BOARD ACTION REPORT – APPEALABLE ITEM

Project Name: Atlantic Crossing (Building I & III) (2021-200)

Request: Class I Site Plan Modification

Meeting Date: August 25, 2021

DATE: 12.03.2013

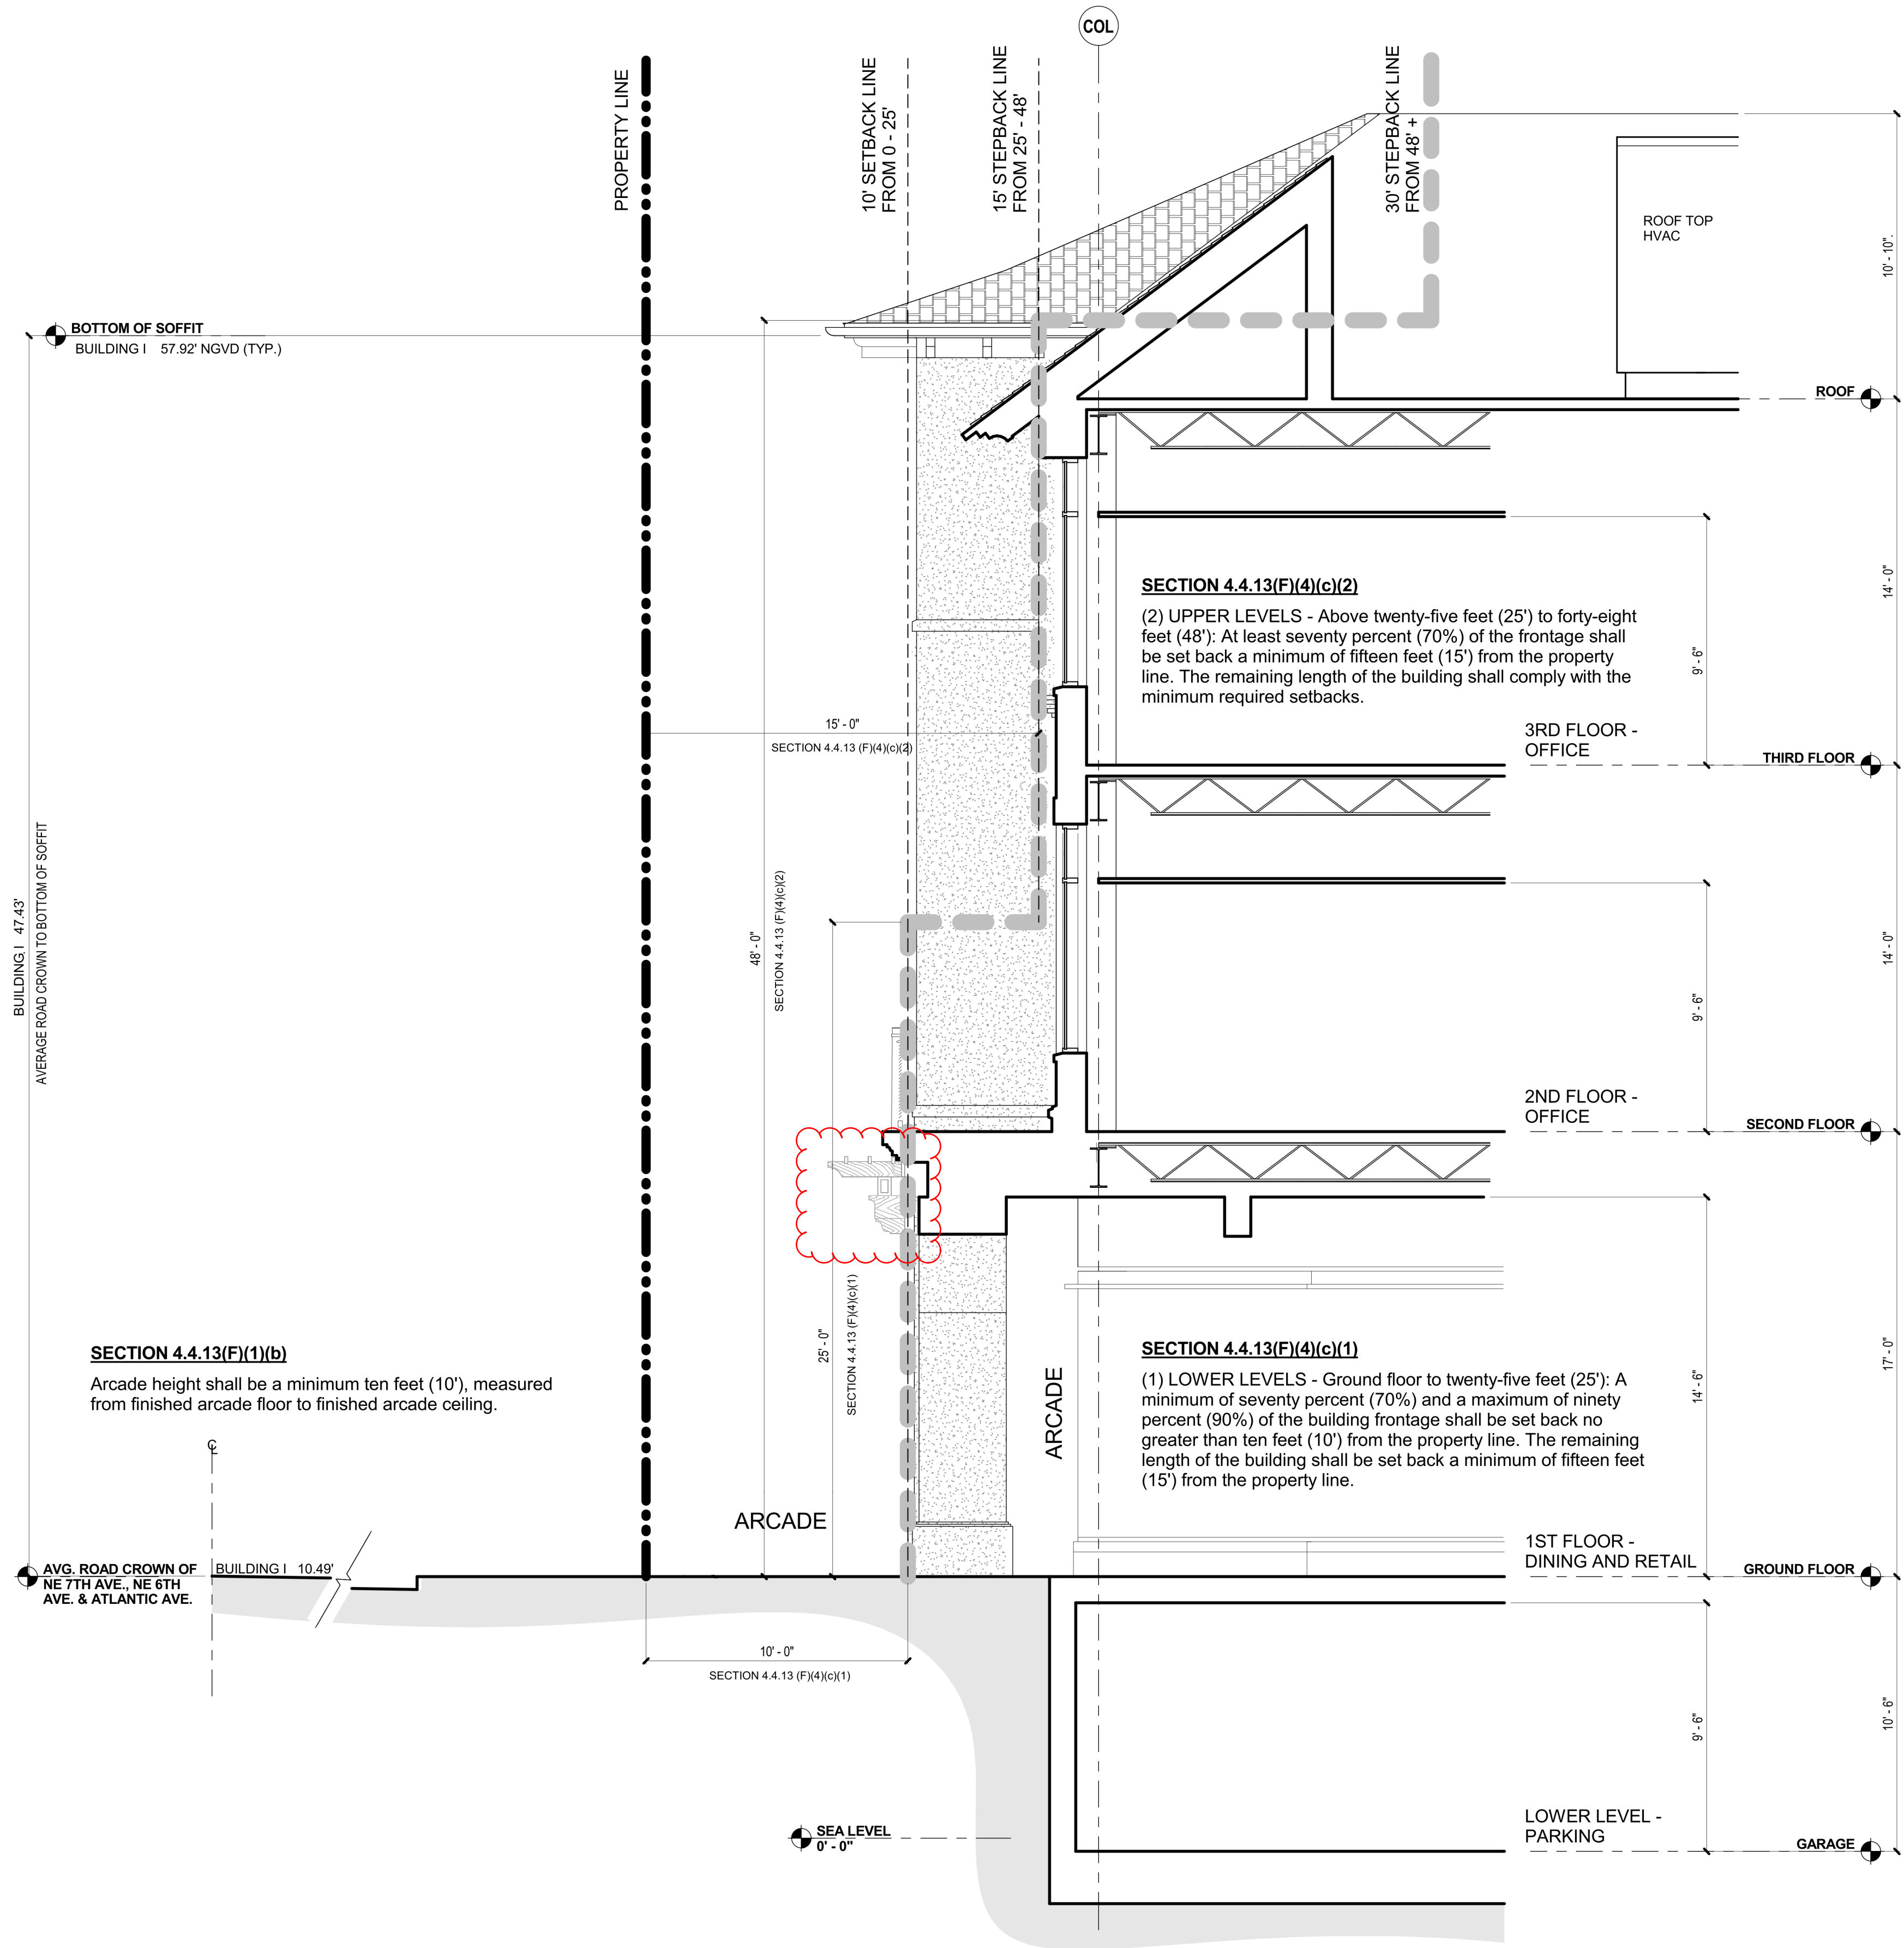
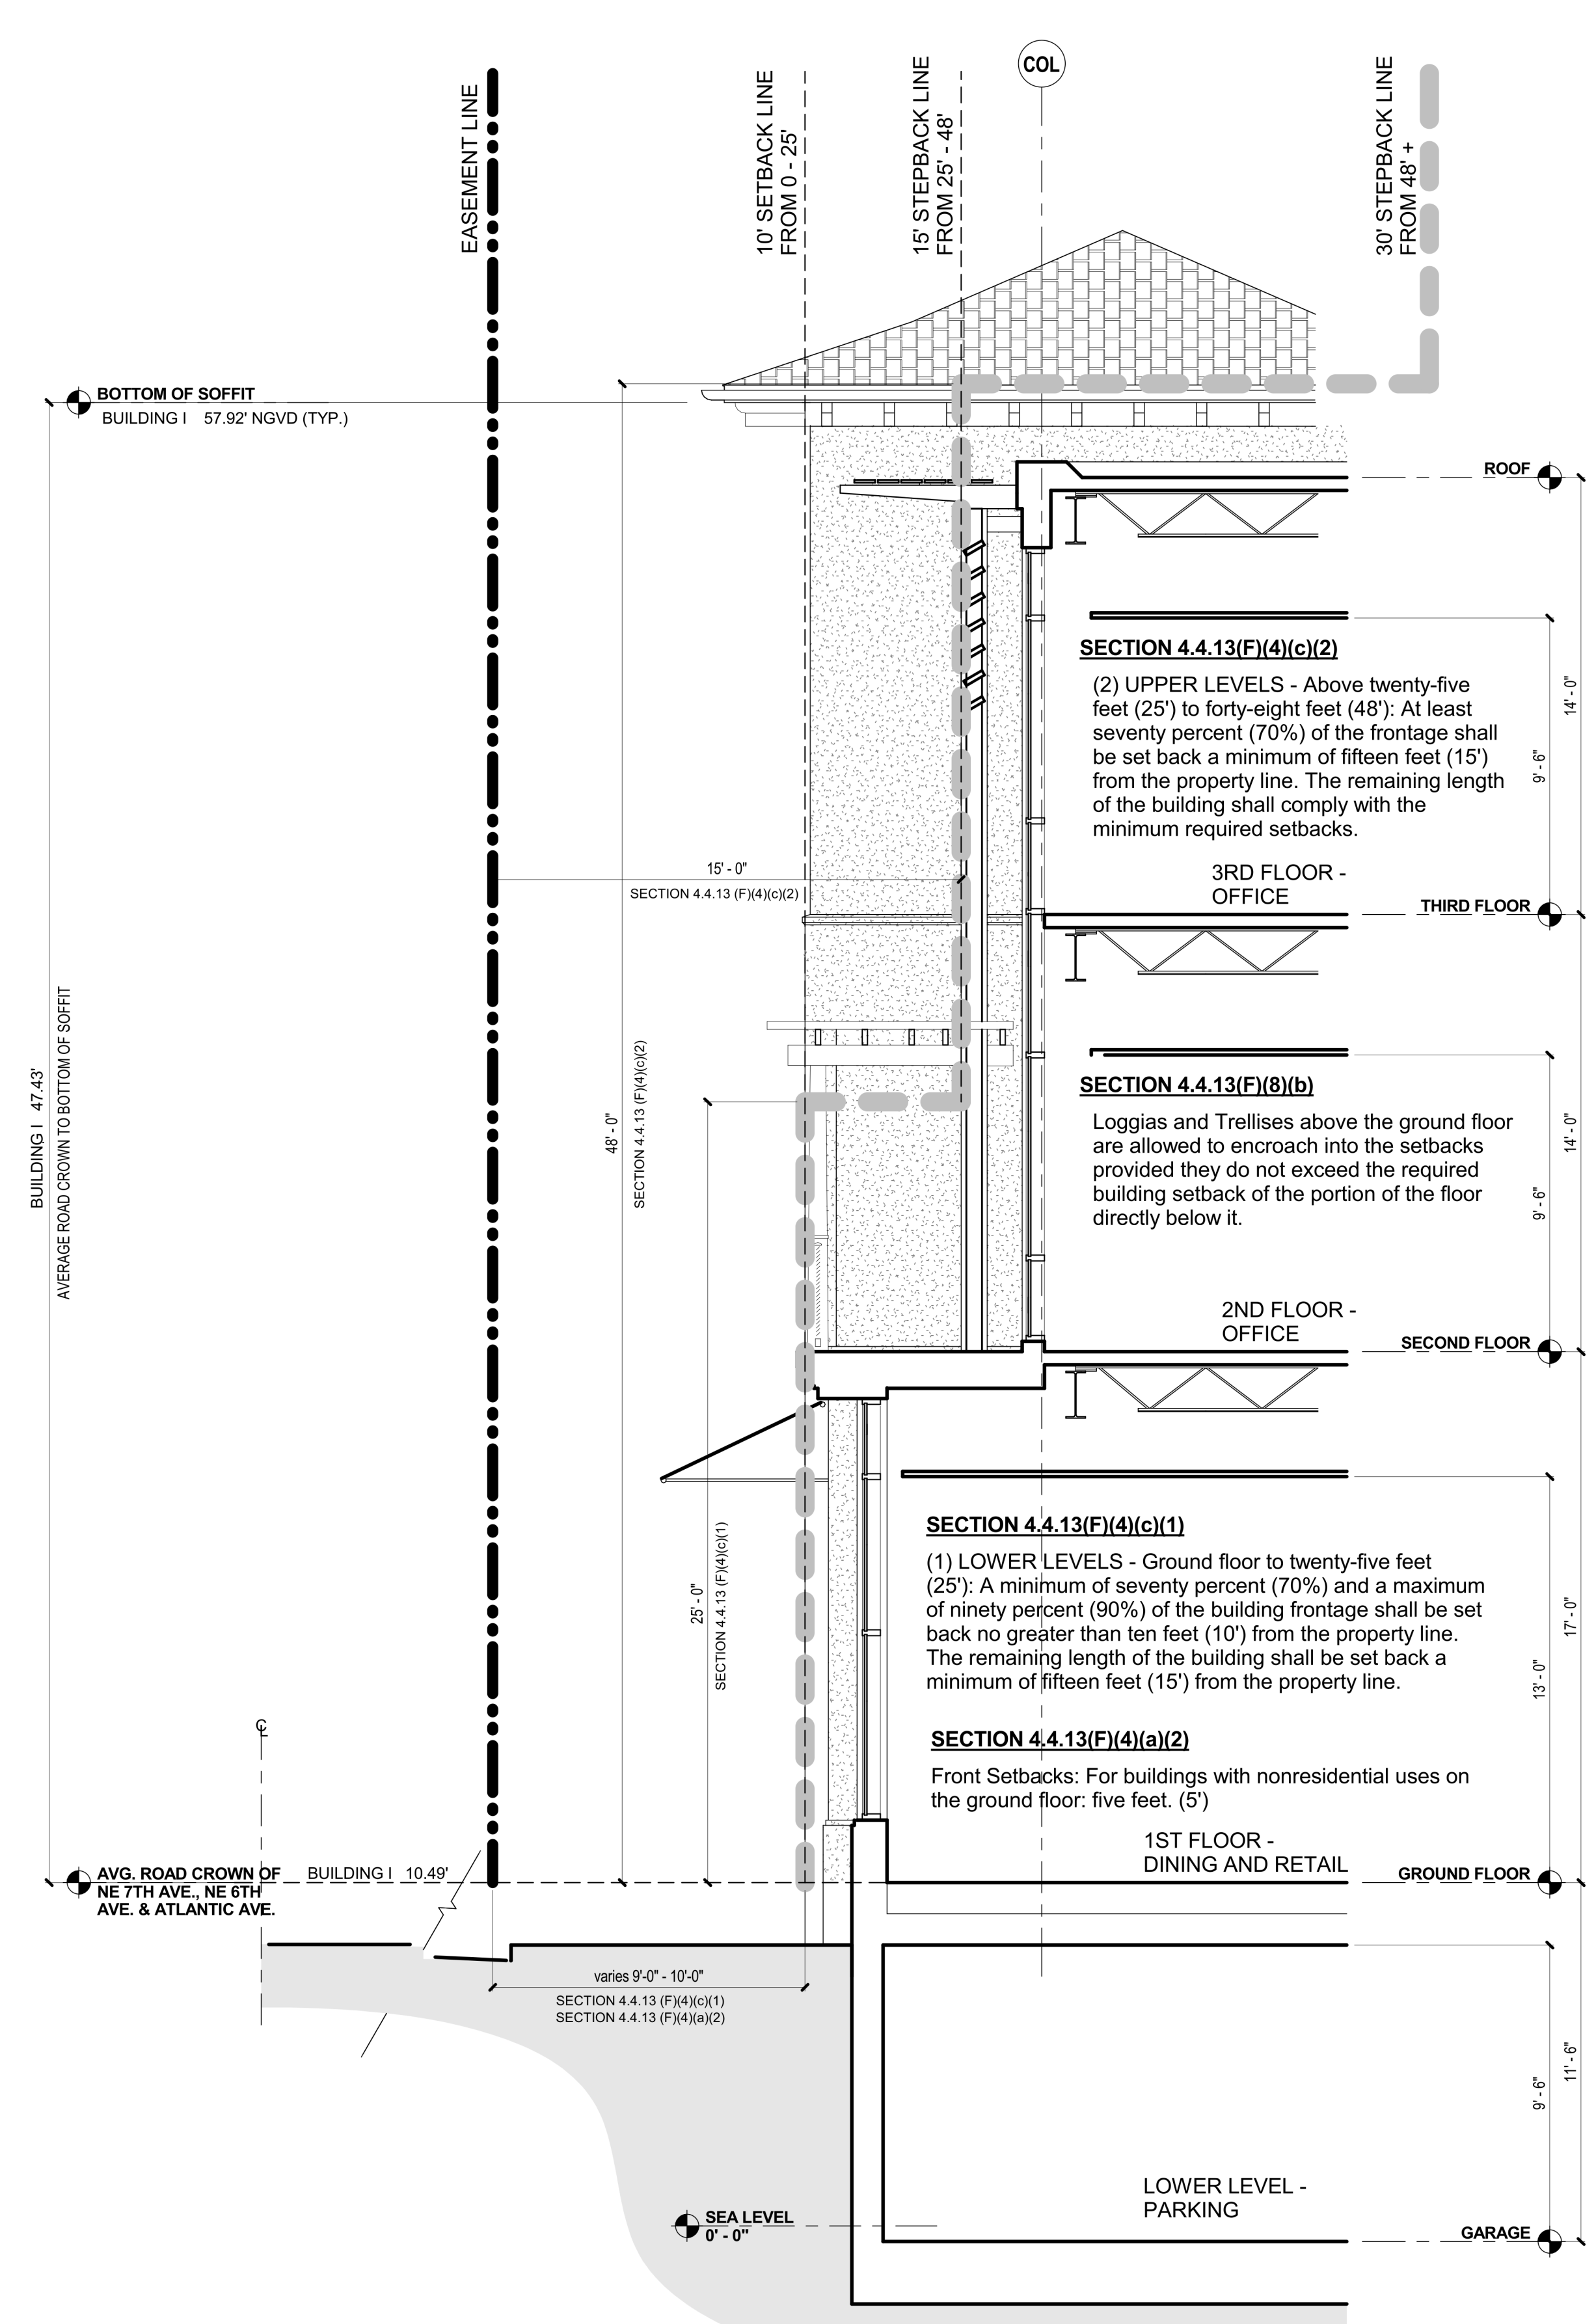
The modification to Building I includes the replacement of a trellis with support columns spanning the width of the entire south elevation, facing East Atlantic Avenue. The replacement is required by the Florida Department of Transportation (FDOT) review, who owns this portion of East Atlantic Avenue. The solution proposed by the applicant is to add individual trellis awnings at a smaller depth of three feet so that support columns are no longer required. The new awnings will be located above two storefronts and the pedestrian passageway leading to the internal courtyard and providing access to the balance of the development. The modifications to Building III includes increasing the green wall area located on the second and third stories of the south and west elevations by eliminating transom windows located below the larger picture windows. The entrance to a commercial space on the easternmost portion of the south elevation is being review from a covered storefront entry to an arched entry finished to match the balance of the building.

Site Plan

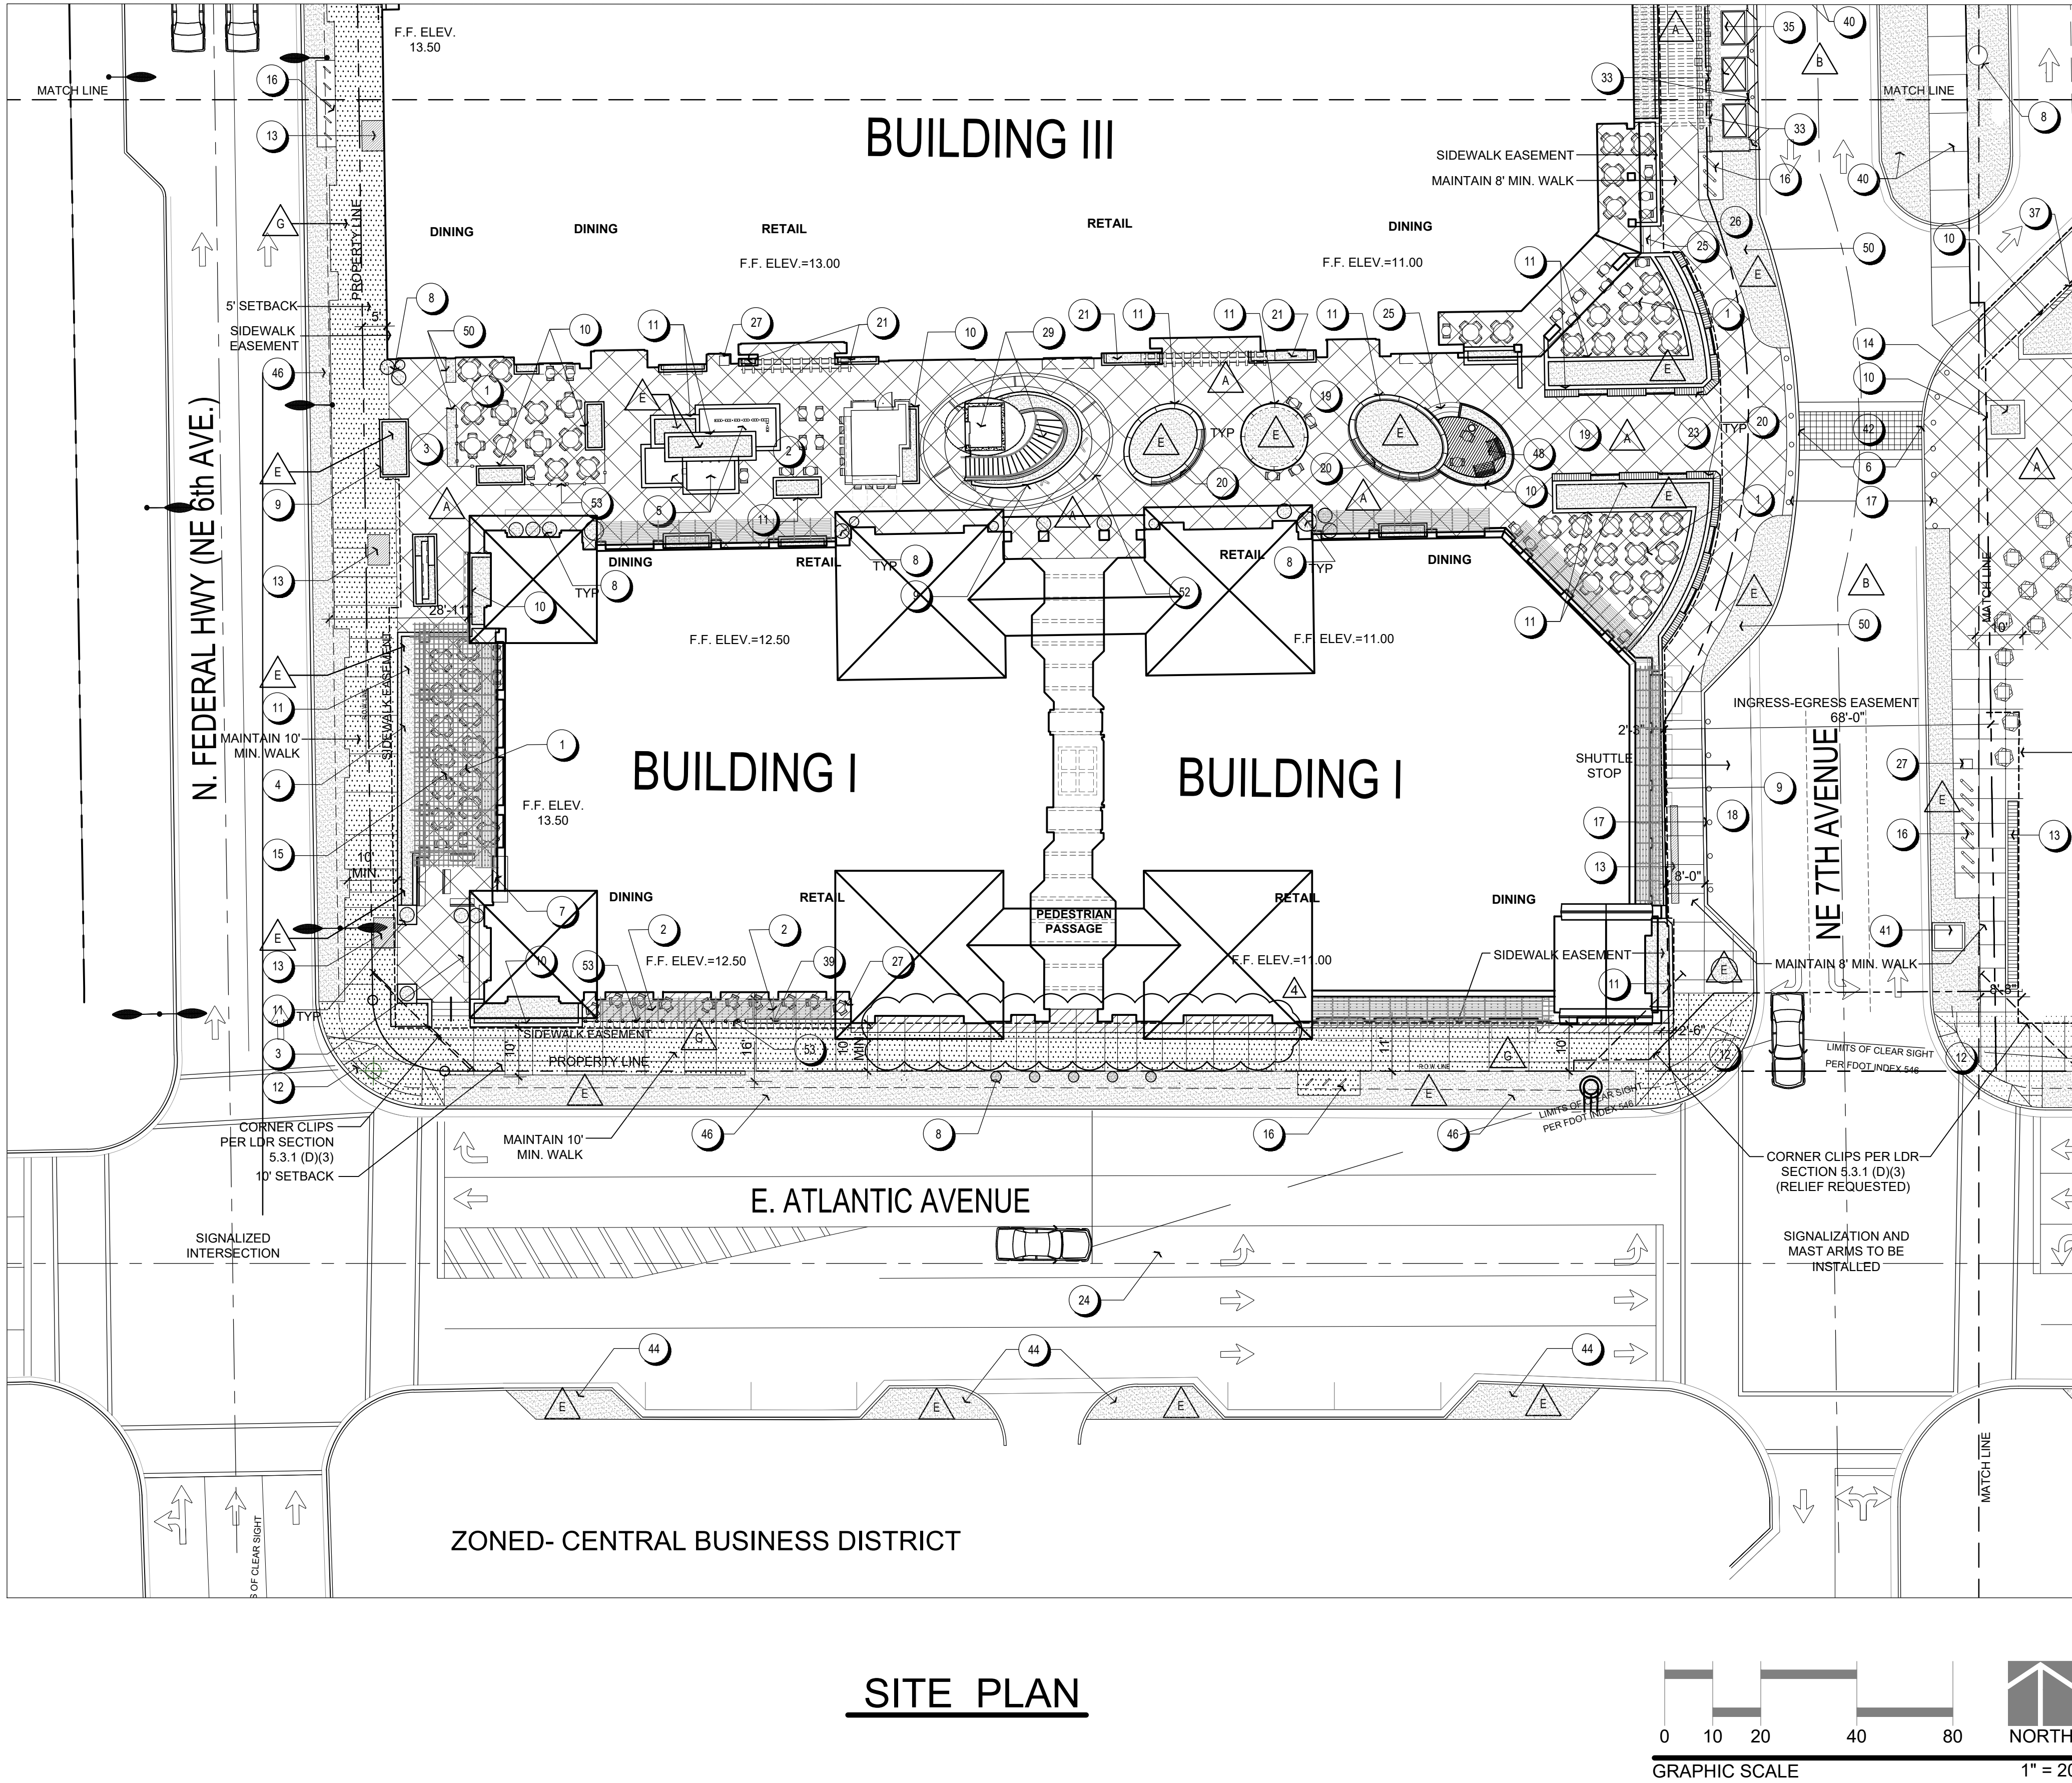
SPRAB NOTE 04/19/2021:

1. REMOVAL OF THE BUILDING TRELLIS AS REQUIRED BY FDOT
